TECHNICAL MEMORANDUM NO. 10

**ADDENDUM TO FINAL PHASE I
RFI/RI WORK PLAN**

Soil Sampling Plan -- Surface Disturbance Areas

**Rocky Flats Plant
Woman Creek Priority Drainage**

FIGURE 1

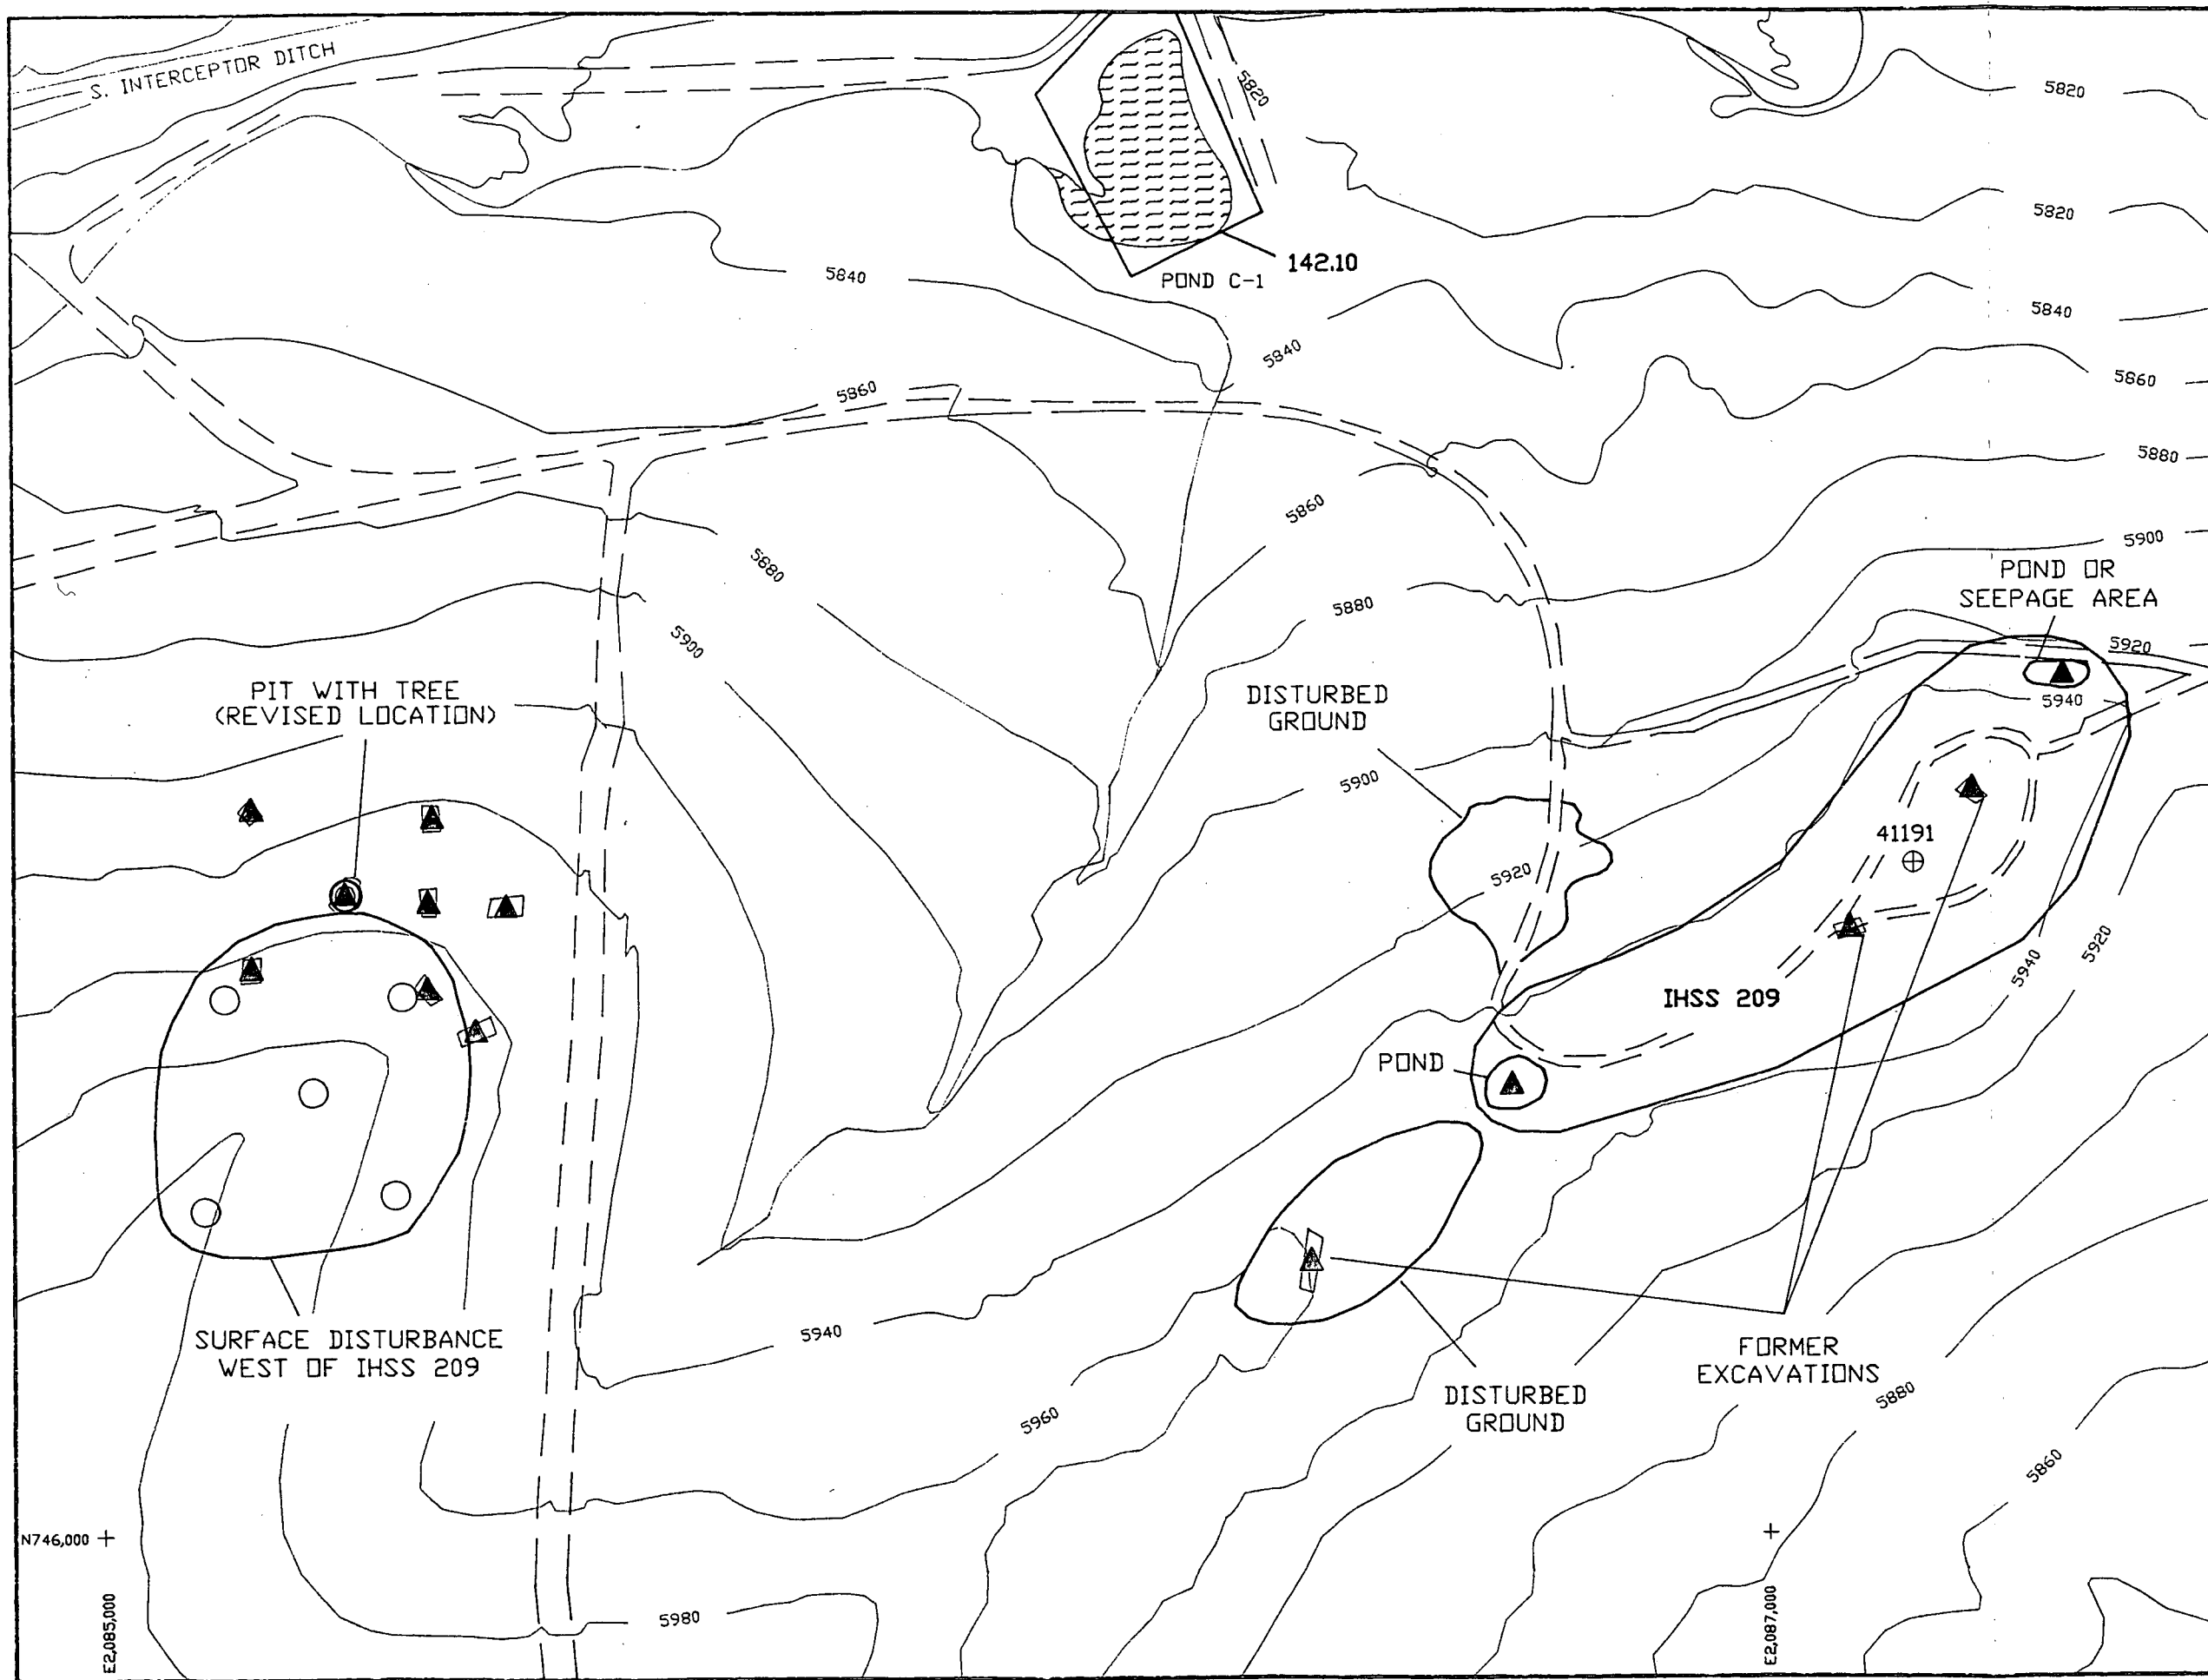
Additionally, a soil borehole that was drilled during the Site Wide program has been identified within IHSS 209 (Figure 1). This borehole (borehole # 41191) was advanced to a total depth of 223.1 feet below ground surface. Alluvium was recorded to a depth of 31.3 feet which was underlain by claystone. During the installation of this borehole six-foot composite samples were collected for analysis of TAL metals and radionuclides, and two-foot discrete samples were collected for analysis of volatile organic compounds. The results of these analyses indicated that manganese was detected at concentrations of 1,280 Mg/Kg and 665 Mg/Kg (upper tolerance limit is 643 Mg/Kg) from depths of 24 ft. - 29.8 ft. and 29.8 ft. - 35.6 ft., respectively, iron was detected at a concentration of 33,700 Mg/Kg (upper tolerance limit is 33,287 Mg/Kg) from a depth of 29.8 ft. - 35.6 ft., and tritium was detected at a concentration of 670 pCi/l (upper tolerance limit is 411 pCi/l) from a depth of 24 ft. - 29.8 ft. Manganese and iron are naturally occurring elements, and are not considered to be out of normal ranges at these concentrations. No other inorganic constituents were detected in concentrations above the upper tolerance limits from this borehole.

Several volatile organic compounds (acetone, methylene chloride, and toluene) were detected in these samples, however, these constituents were detected sporadically and are all common laboratory contaminants. Other samples from this borehole with these "hits" were flagged in the Rocky Flats Environmental Data System (RFEDS) data base as being less than the detection limit, or as being in the laboratory blank. Based on the analytical results from borehole 41191, additional soil boreholes should not be required in this area.

indicate that the vegetation and upper sediments had been striped from the area prior to 1955, and that prior to 1964 several pits had been opened within the site. The review of the photographs subsequently resulted in an extension of the overall length of the IHSS as compared to the dimensions shown on Figure 2-7 of the OU5 Work Plan, and some adjustments to the locations of the pits that were also shown on Figure 2-7. The two pond sites were added to Figure 1 as a result of Stage 1 activities.

The pond, shown on Figure 1, to the southwest of the road is first visible on the 1980 photograph. As a result of Stage 2 reconnaissance this pond was found to be at least ten feet in depth and dry. The pond, shown on Figure 1, on the northeast end of the site occurs at the base of a hill and is first visible on the 1955 aerial photograph. The northeast pond was bisected by a road prior to 1964, and currently appears to be a seepage area with abundant vegetation.

The area to the west of IHSS 209 consists of eight pits that are first visible on the 1955 vertical aerial photograph of the RFP area. The Stage 1 aerial photo review resulted in relocating the pits approximately 250 feet to the north with respect to the locations shown on Figure 2-7 of the OU5 Work Plan. Three additional pits were identified as a result of Stage 1 activities and confirmed during the Stage 2 field reconnaissance.

The Stage 2 field reconnaissance confirmed the locations of all eight pits identified on the 1955 aerial photograph (Figure 1). The largest pit is located near the center of the site and was found to be several feet deep. The largest pit is currently dry but has obviously held water during periods of wet weather or snow melt, and is now the host for a fairly large cottonwood tree indicating that the sight has been open for a long period of time. The remaining pits are small and shallow, appear to be capable of holding water during wet weather, and are heavily re-vegetated. There is no indication that any of these pits had ever been used as disposal sites.

This TM proposes the installation of 4 soil boreholes rather than the original proposed number of 19. The purpose of each borehole is to provide:

Boreholes will be drilled six feet into bedrock. Figures 1 and 2 show the proposed soil borehole locations. The drilling and soil sampling techniques that will be implemented during this drilling program are described in the following sections.

FIGURE 2

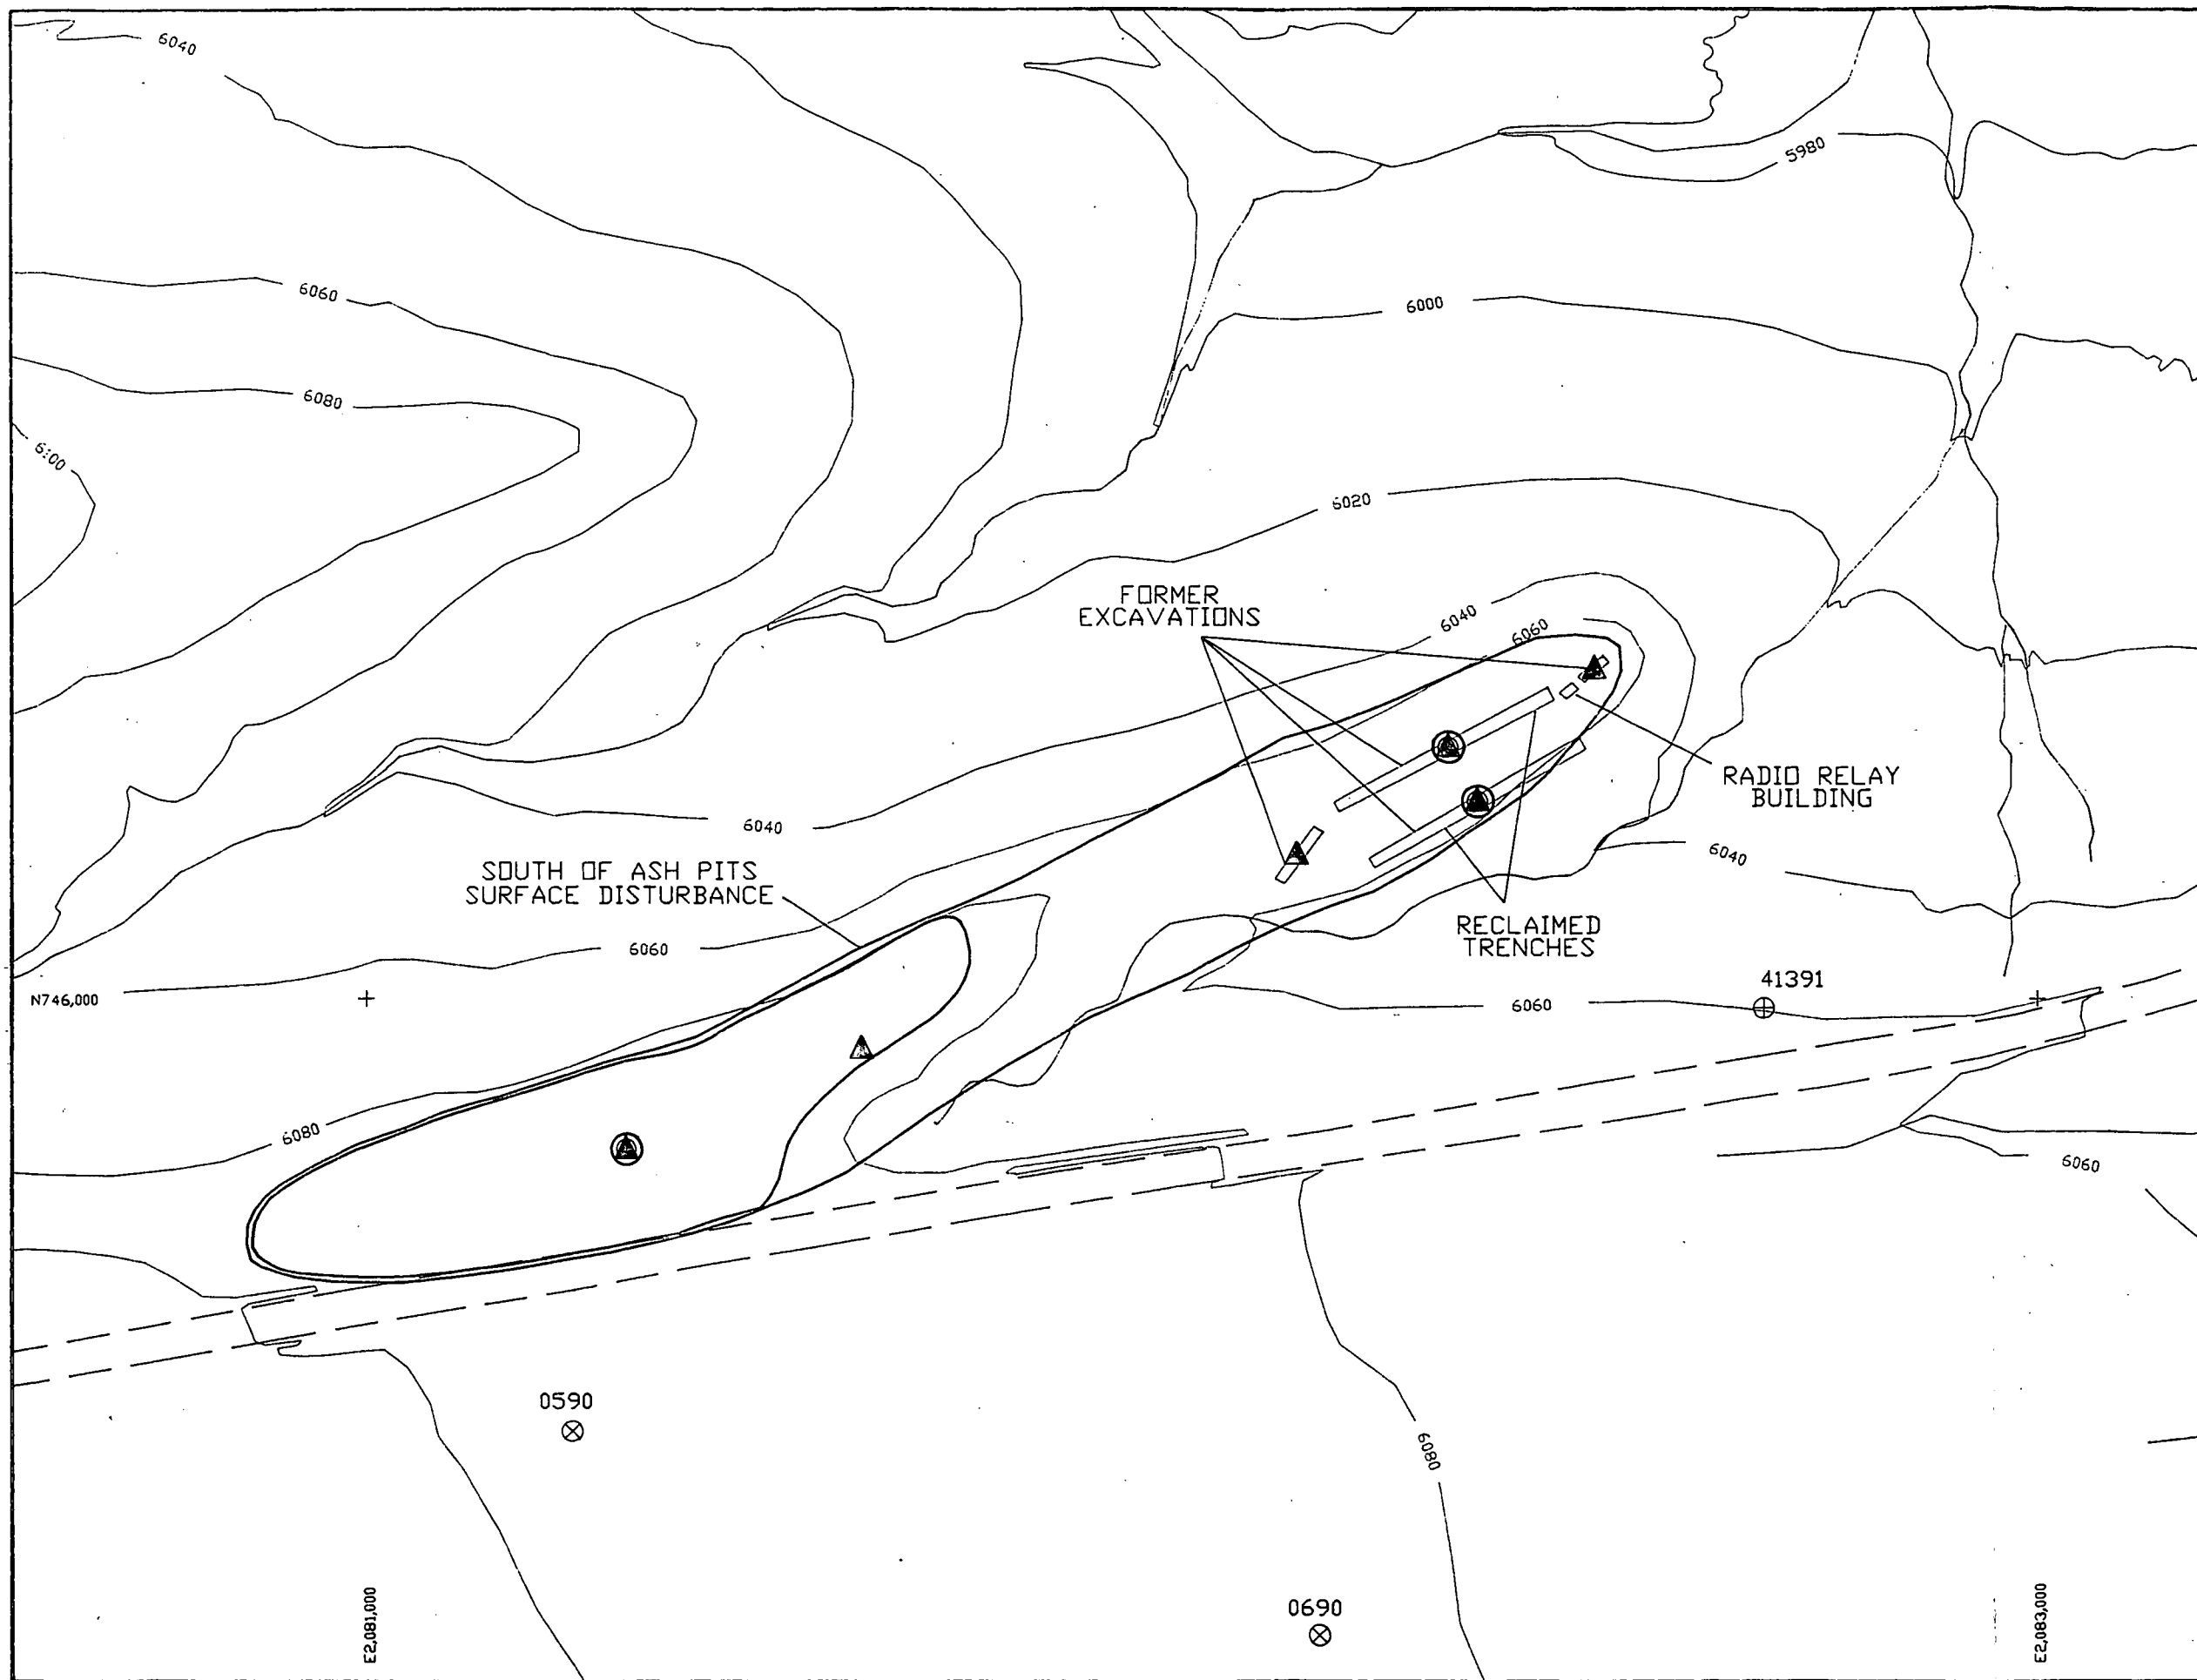
The area to the south of the IHSS 133 group is shown on Figure 2 and consists of an area of disturbed ground, and an area that contains two open and two reclaimed pits. The area containing the disturbed ground comprises the southwest end of the site and is approximately 1,000 feet in length, and from 50 to 150 feet in width. The open and reclaimed pits are located in the northeast half of the site. The locations of the pits shown on Figure 2 have been corrected as a result of Stage 1 activities, according to scaled locations from the aerial photographs, and do not agree with the locations shown on Figure 2-6 of the OU5 Work Plan.

The smaller pits shown on Figure 2 are both open. The pit shown on the southwest end of the site is a drainage ditch that diverts runoff water to the south, and shows no indications as having been used as a disposal site. The open pit shown on the northeast end of the site is approximately twenty feet in length, 2 to 3 feet deep, and shows no indications as having been

The elongated parallel pits shown on Figure 2, were opened prior to 1978, and were apparently reclaimed soon after that time. The area was re-contoured and is now completely re-vegetated. There are no indications of debris or staining associated with these sites.

No evidence was found, as a result of the Stage 1 and 2 activities, to support the existence of the horseshoe shaped pit described in the OU5 Work Plan. Topographically this area of the site is an elongated northeast trending nose with moderately steep slopes defining the northeast end of the structure. The alluvial materials exposed along these slopes can account for the appearance of a pit or disturbed area on the aerial photographs; however, Stage 2 field reconnaissance did not substantiate the existence of a horseshoe shaped pit.
